**TOWN OF BAY HARBOR ISLANDS
MORRIS N. BROAD COMMUNITY CENTER
1175 95TH STREET
BAY HARBOR ISLANDS, FL 33154**

DEVELOPMENT & REVIEW COMMITTEE MEETING

ITEM: Review and discussion of the Site Plan Application by Arman Corp., to construct a new 6-unit Townhouse Development to be located at 1085 94 Street. Enclosed are the Site Plans and the Staff Report prepared by Town Planner Michael Miller.

Subject: Site Development Plan Application (3rd DRC Review)
1085 Townhouses – 6 DU Townhouse Complex
1085 94th Street
Bay Harbor Islands Acct. No. SPR24-000025
MMPA Account No. 01-0702-1197

DESCRIPTION:
ROOFTOP
NORMAL POWER

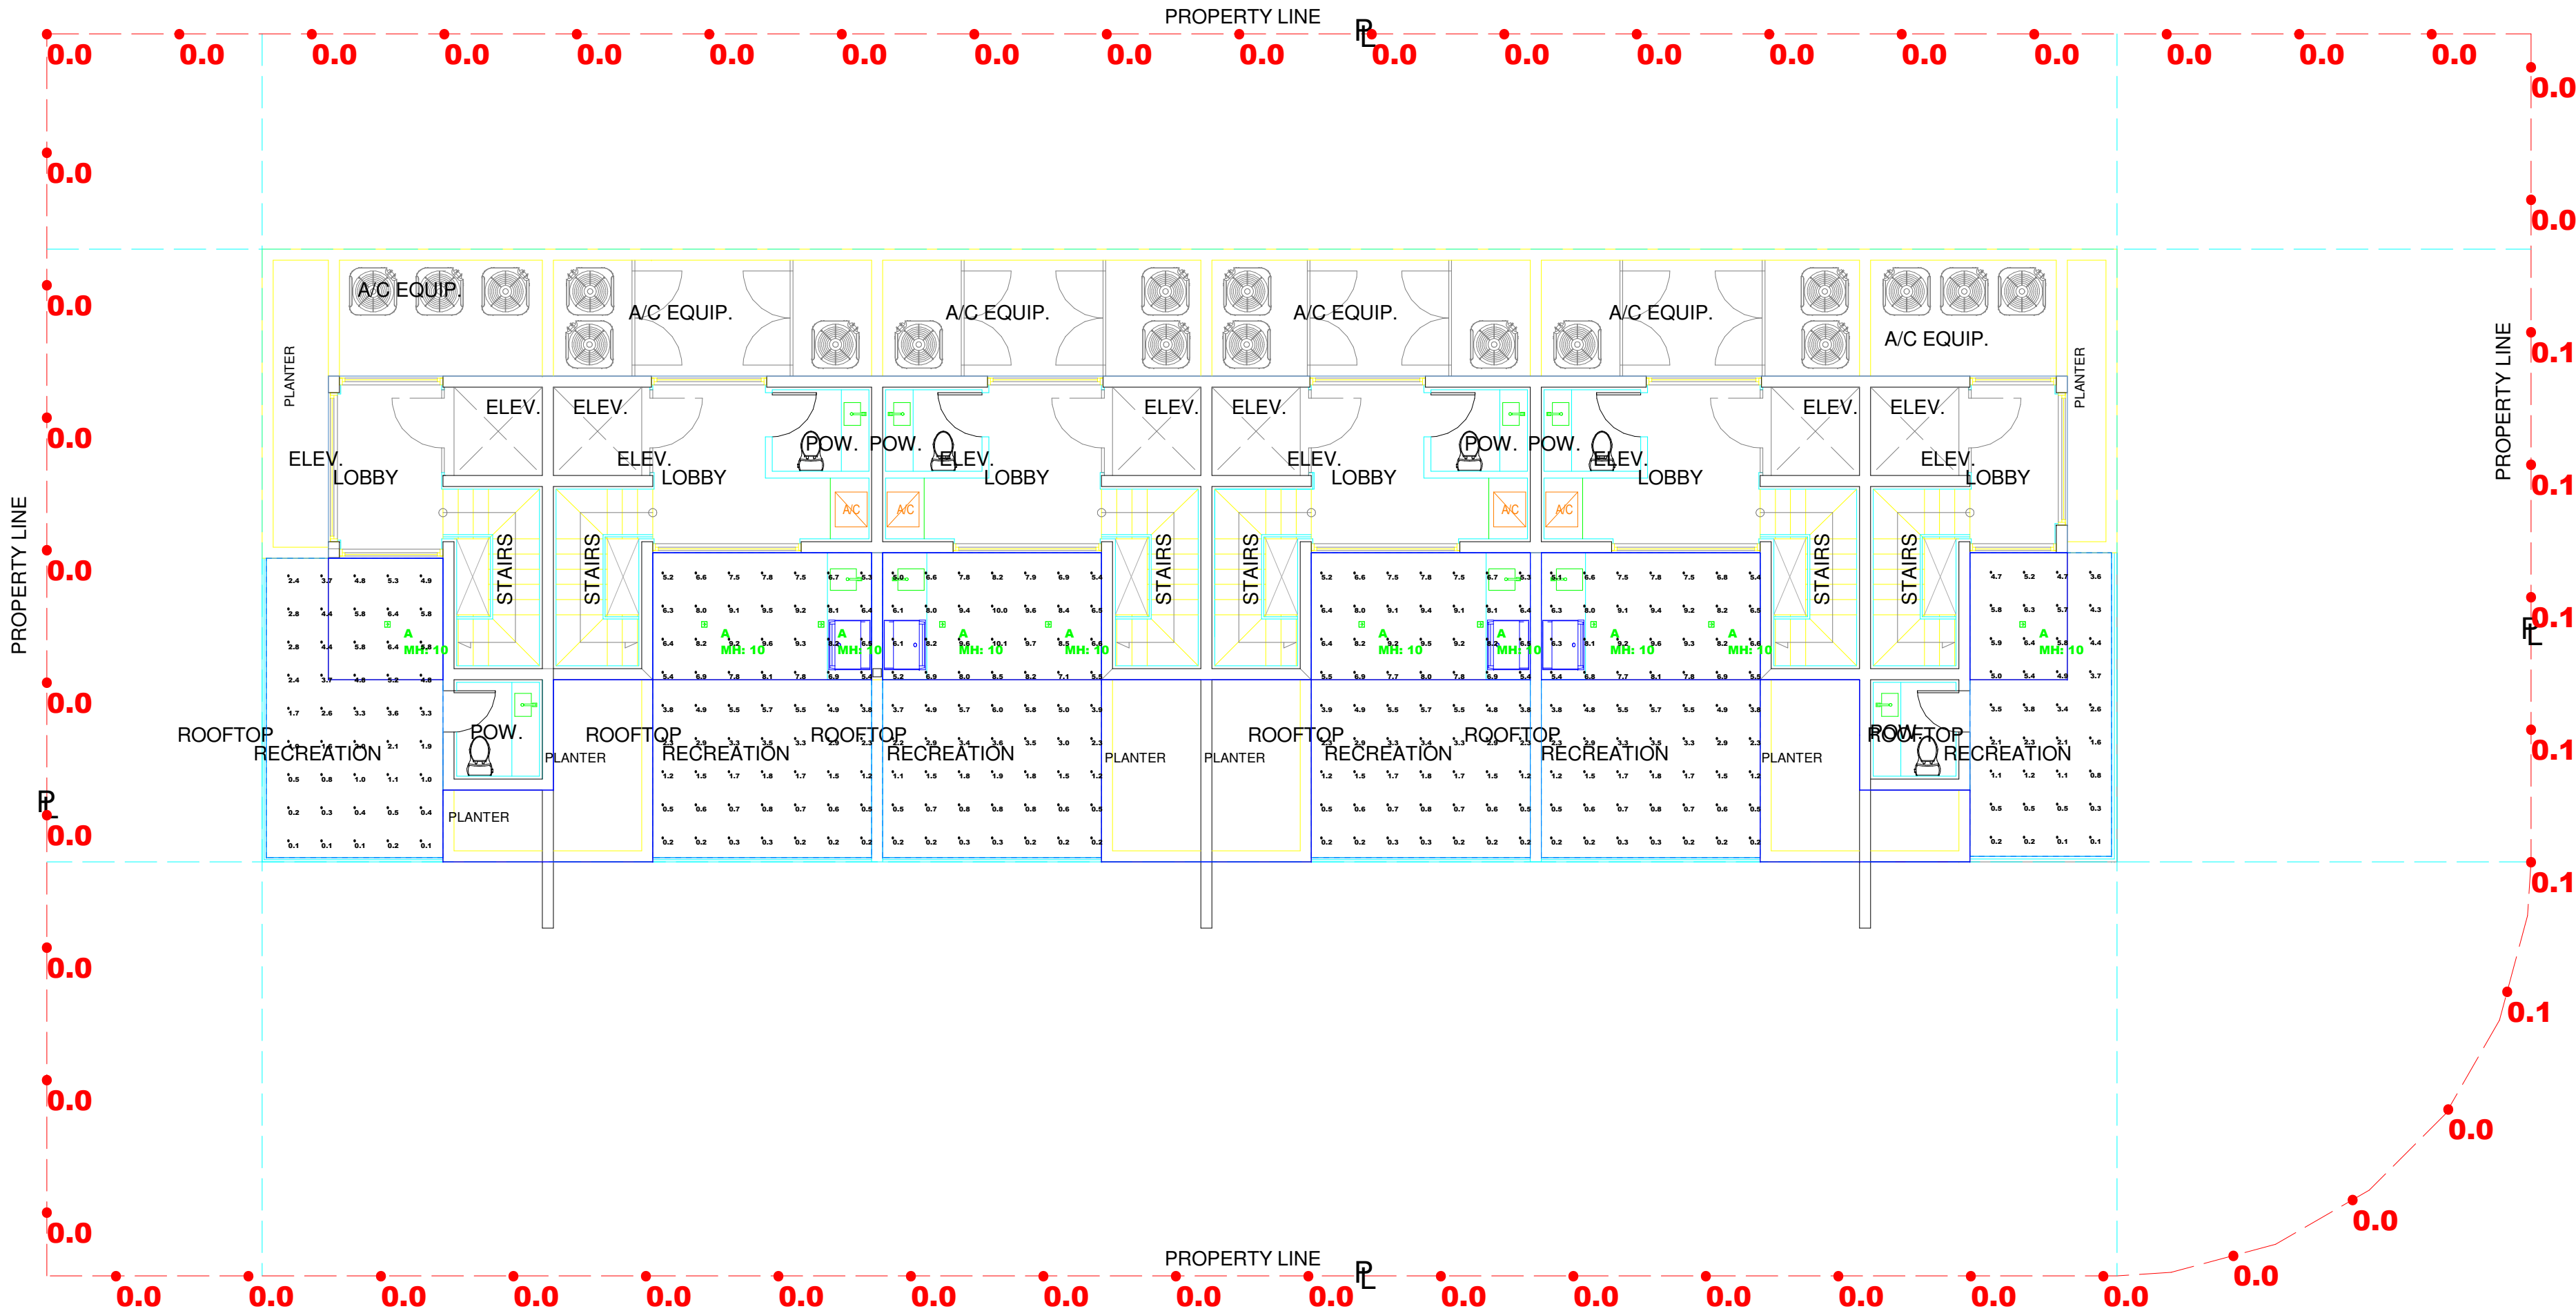
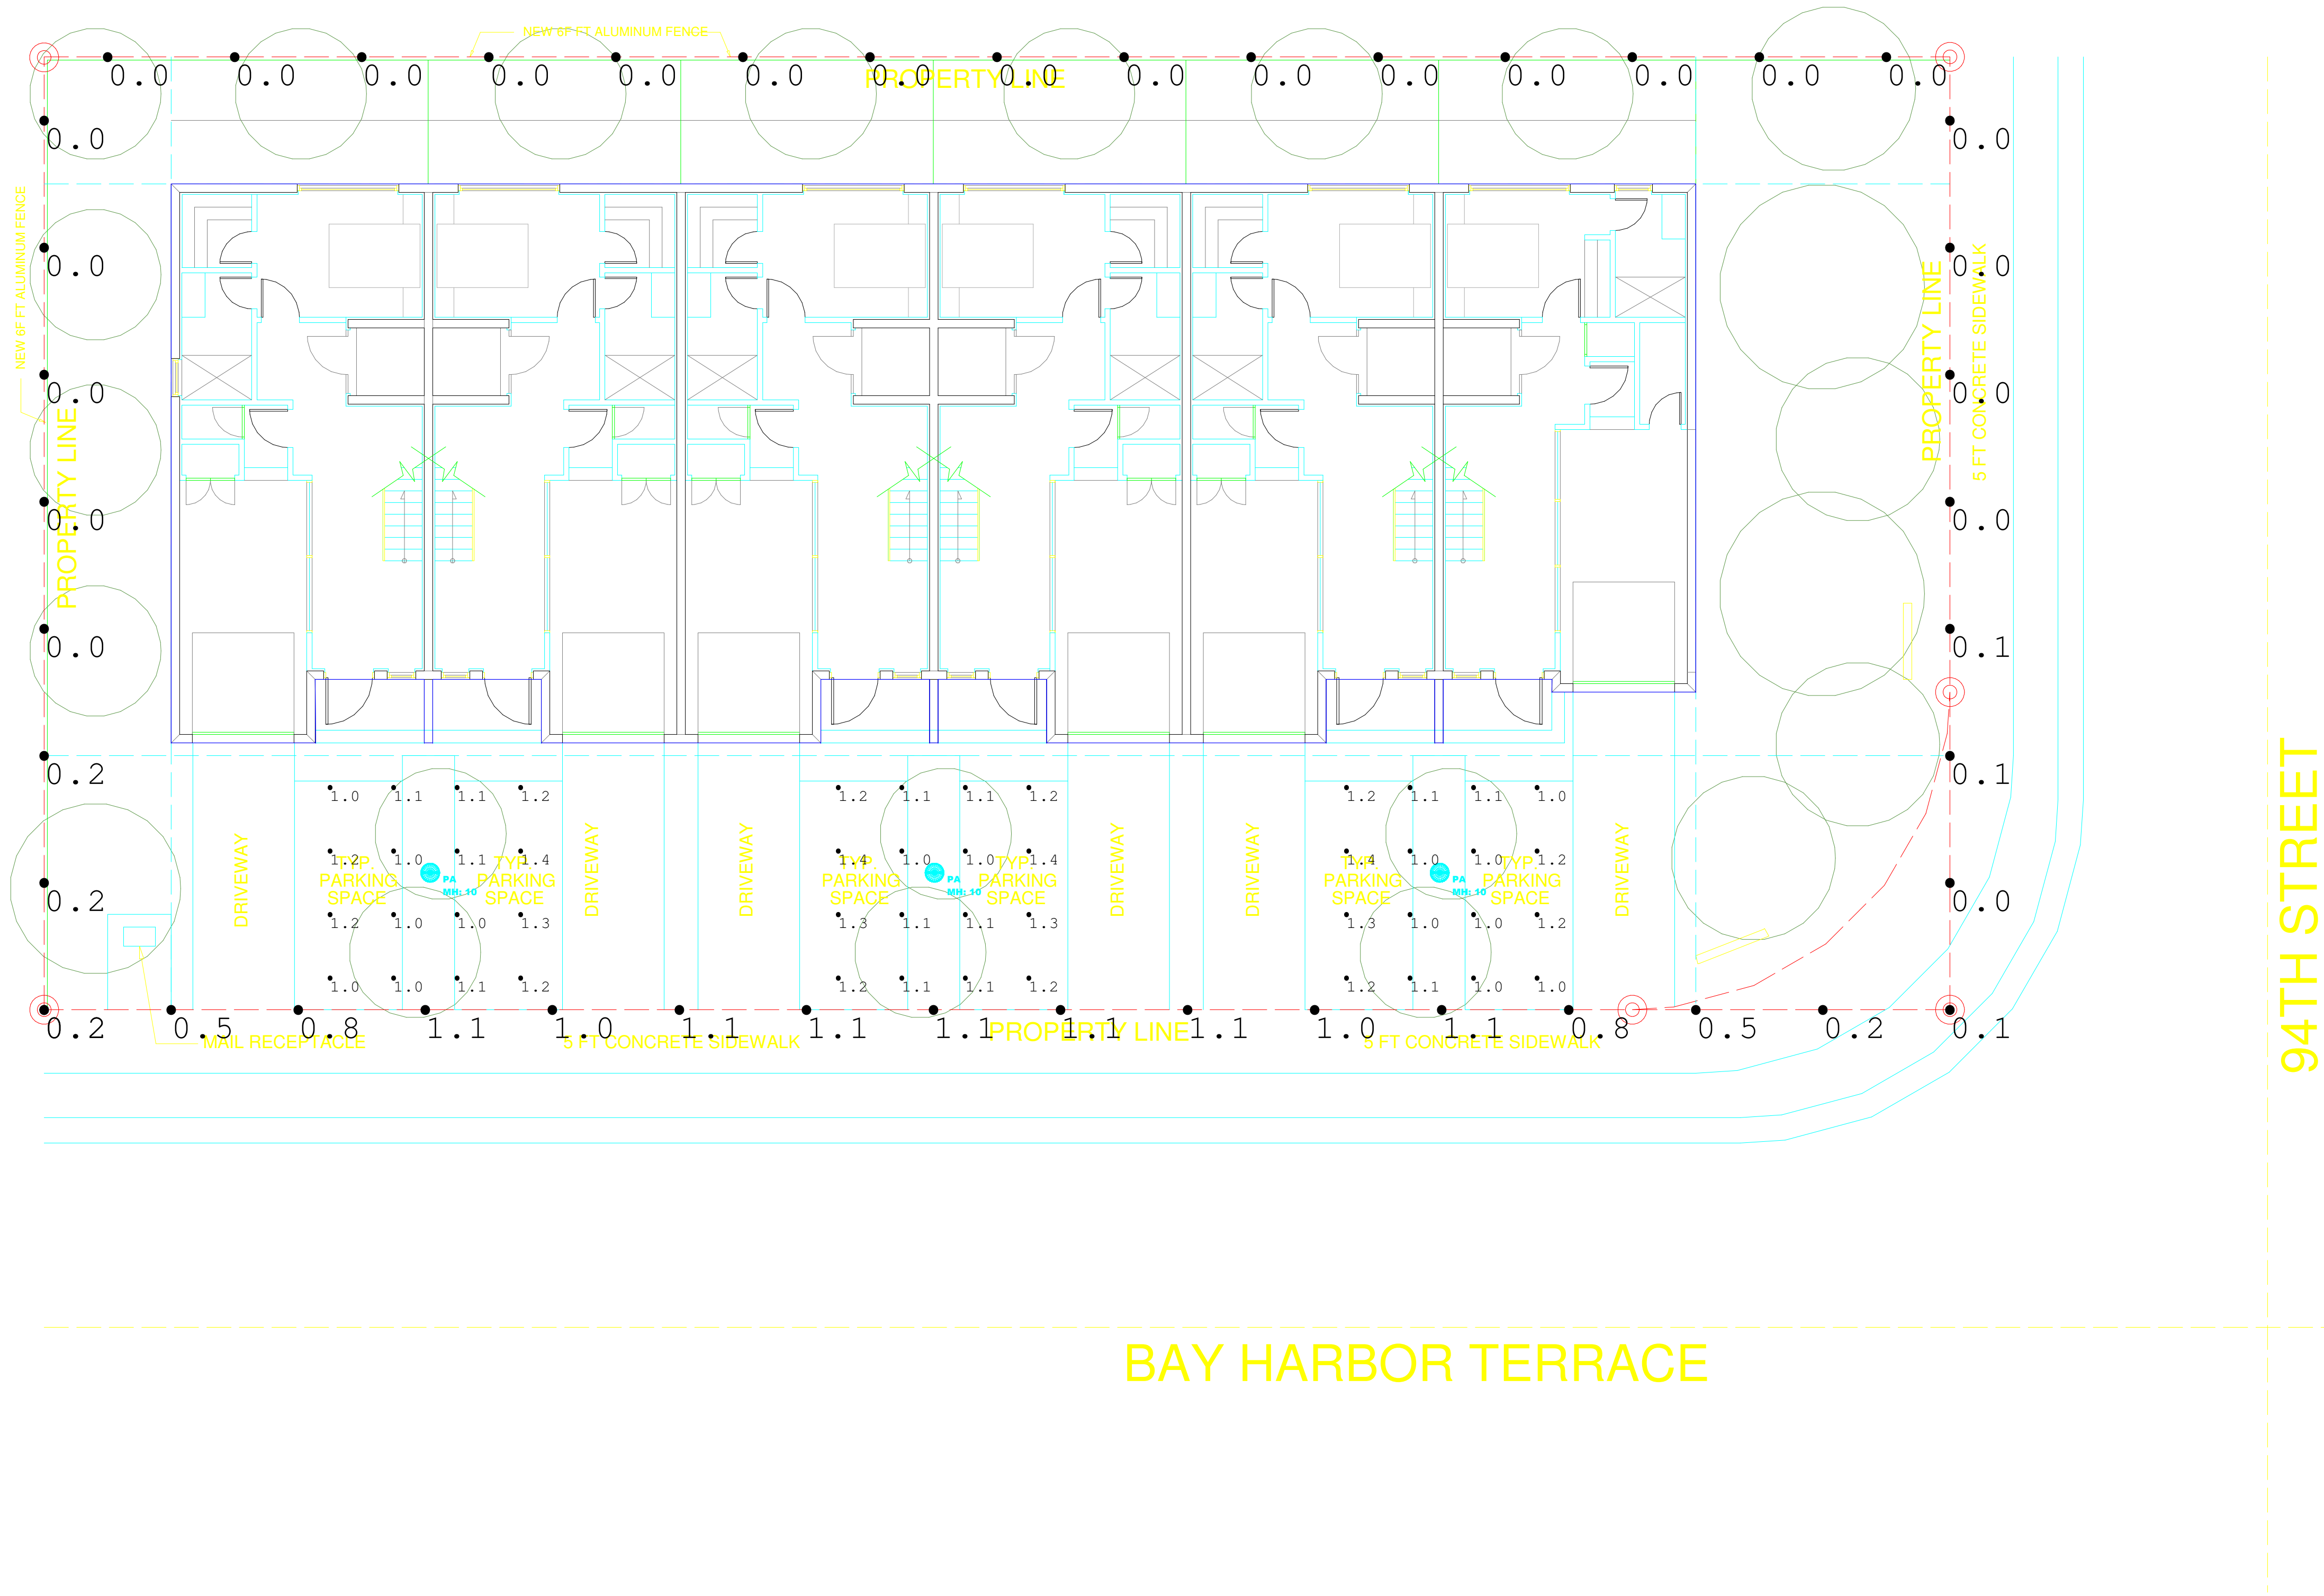
- 2) Per Sec. 23-19 a preliminary Photometric Plan must be submitted showing foot-candle readings at all property lines and on the rooftop. The re-submittal package now includes a preliminary plan. Again, the maximum foot-candle reading allowed at any property line in 1.0; however, the plans show several locations where the 1.0 is exceeded. Revise.

5) Per Sec. 23-19 a preliminary Photometric Plan must be submitted showing foot-candle readings at all property lines and on the rooftop. None was submitted despite our previous request. As a matter of information, the maximum foot-candle reading allowed at any property line is 1.0.

Photometric plans provided as requested. Refer to photometric files.

ROOF
LANDSCAPE
PLAN

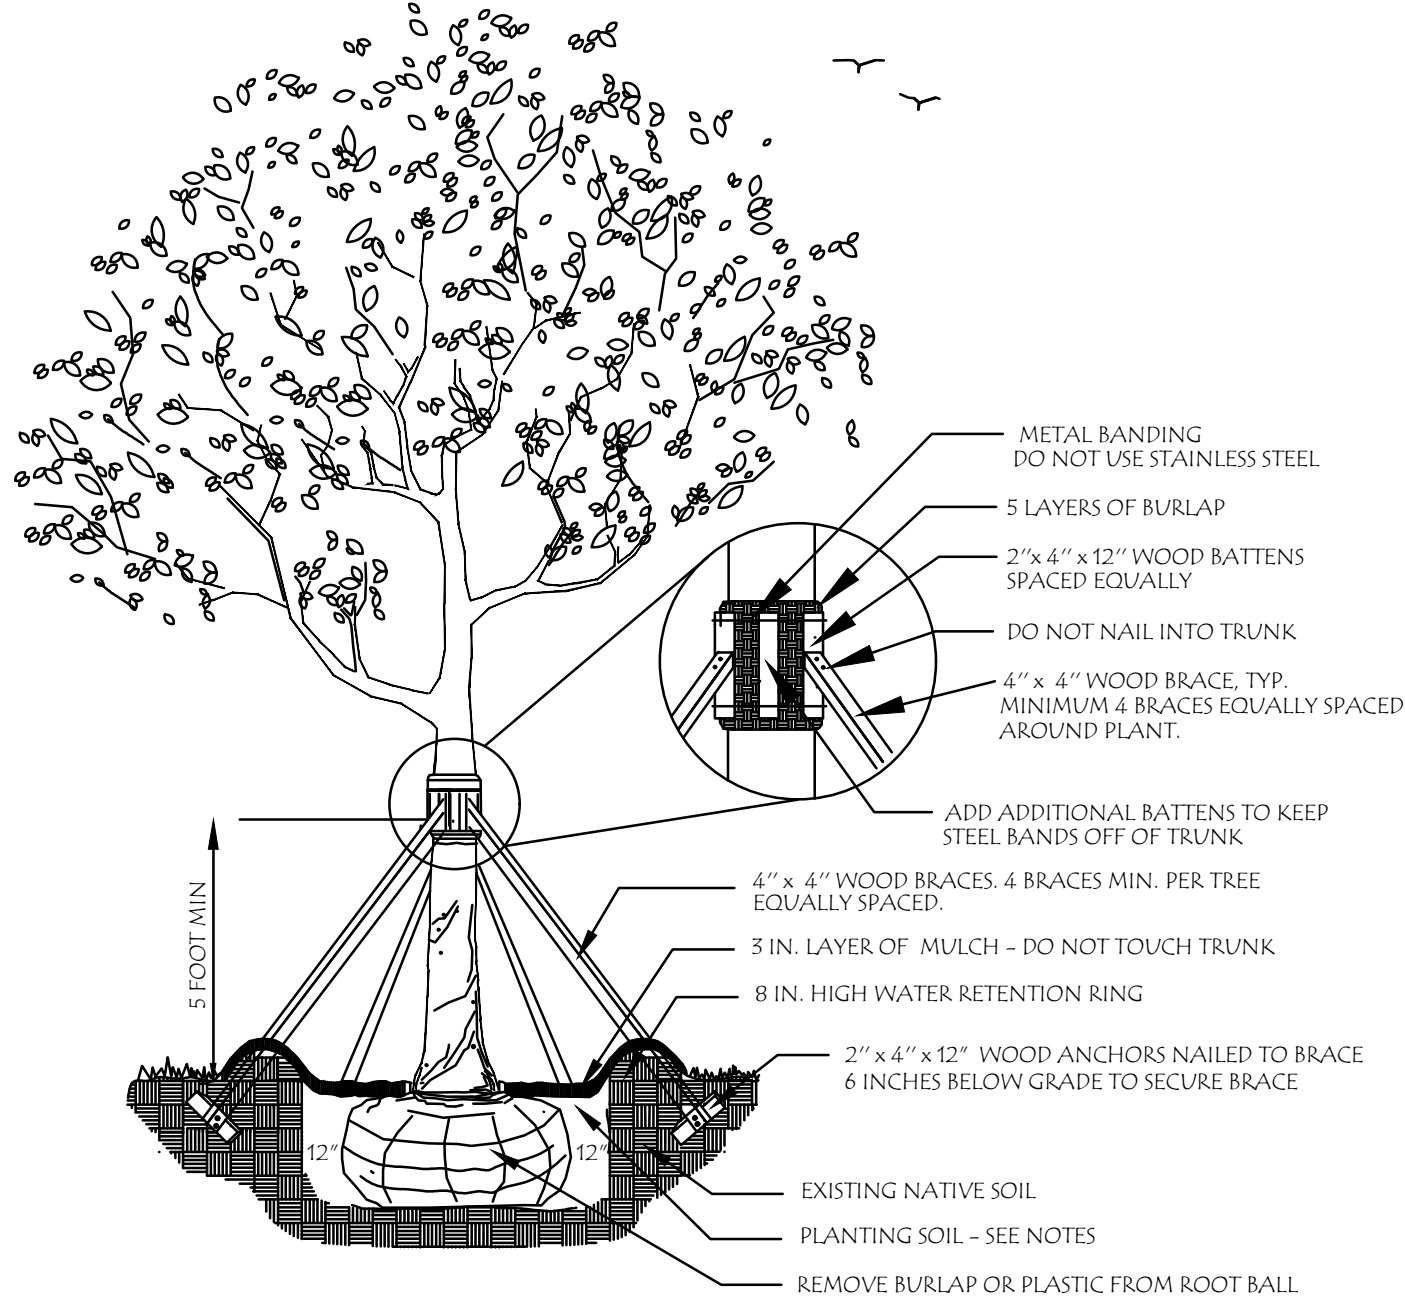
- a. Comment 4: Open Roof Planting
The required 15% landscaping on the rooftop is now shown on Sheet L-2 per Town code.
- b. Comment 10: Street Trees
Along 94th Street the sidewalk has been removed from the Site Plan, and the required Mahogoni street trees have been moved into the R.O.W. per Town code.
